NUCLEAR ENERGY AGENCY
RADIOACTIVE WASTE MANAGEMENT COMMITTEE

THE LONG-TERM RADIOLOGICAL SAFETY OF A SURFACE DISPOSAL FACILITY FOR LOW-LEVEL WASTE IN BELGIUM

An international peer review of key aspects of ONDRAF/NIRAS' safety report of November 2011 in preparation for the license application (Final report)

Figure 3.1: Overview of ONDRAF/NIRAS' safety approach and its relation to safety strategy (ONDRAF/NIRAS 2011b)

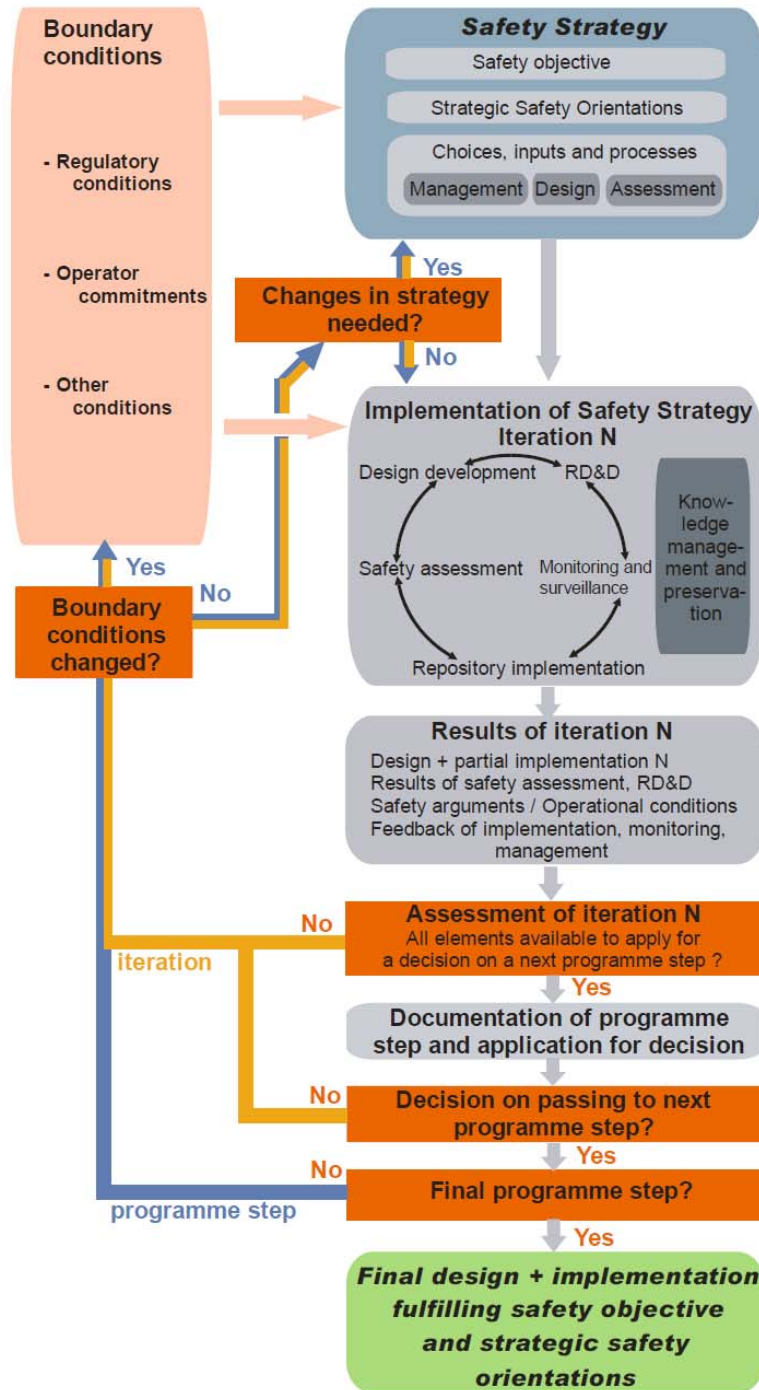
The IRT considers that the iterative process described by ONDRAF/NIRAS for disposal system development and implementation, suitably controlled by an appropriate management system, is appropriate and should allow the incorporation of new knowledge, while maintaining flexibility in the decision making process according to the international recommendations and practices (NEA 2004).

Figure 3.7: ONDRAF/NIRAS’ scenarios (Vermariën and Cool, 2012b)

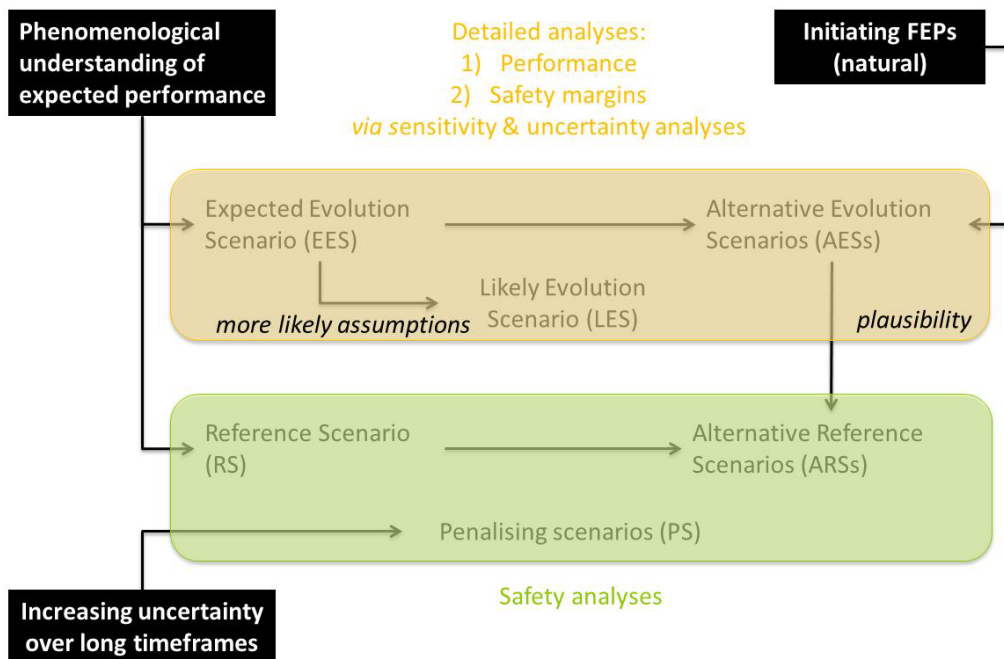
During the peer review week, ONDRAF/NIRAS provided additional information including, a presentation by Vermariën and Cool (2012b) that introduced a new categorisation of scenarios (Figure 3-7). The new scheme, presented in Figure 3-7, includes a Likely Evolution Scenario (LES), which appears to be considered somehow ‘more likely’ than the Expected Evolution Scenario.

The IRT considers, however, that it is complex to comprehend the relationships between the various scenario types defined by ONDRAF/NIRAS. For example, the relationship between the AES and ARS type scenarios. It is also noted that ONDRAF/NIRAS (2012d) only addresses the AES scenario type and does not address ARS type scenarios.

Figure 3.8: ONDRAF/NIRAS’ synthesis of calculated radiological impacts for different scenarios (Minon, 2012b)

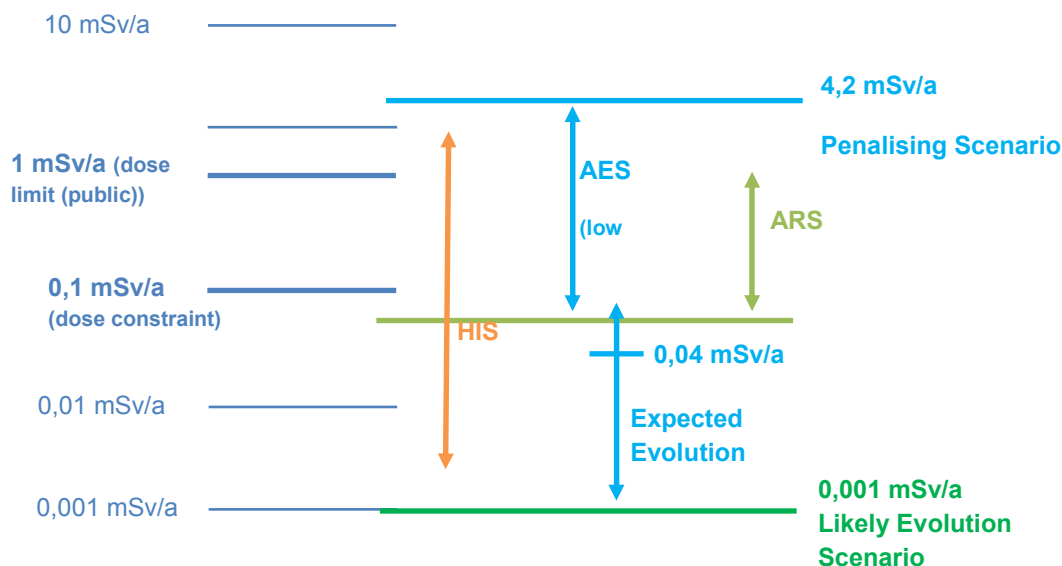
The IRT observes also that, in the safety assessment, ONDRAF/NIRAS has made reference to the international ICRP recommendations (ICRP-103) for radiological impact calculations. The calculated radiological impacts in the safety report, as well as other later calculations, are within the ICRP allowed ranges for the various different scenarios,

including the ‘penalising scenario’, and are illustrated in Figure 3-8. The IRT, however, has questioned some assumptions made by ONDRAF/NIRAS and has suggested additional calculations, which may or may not confirm the results of the current assessment.
